SERVICE BULLETIN

GAME NAME: CYCRAFT (INITIAL D3, CLUB KART)

SUBJECT: • SAFETY LINK, WRONG WAY OF MOUNTING

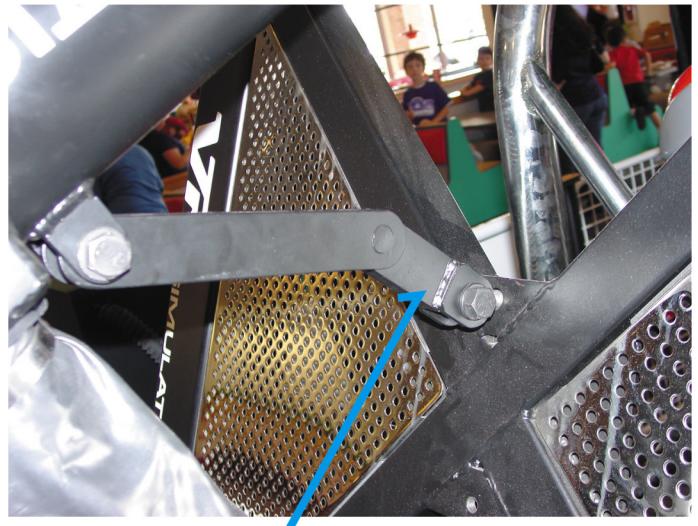
Please DO NOT mount SAFETY LINK wrong way that cause of TOSHIBA Motor Drive Board issue. Game works fine while but stop at error when Cockpit goes uper position.

This is NG. (Short part of Safety link come to Actuator side then joint part is hitting to actuator.)

This is GOOD!!!
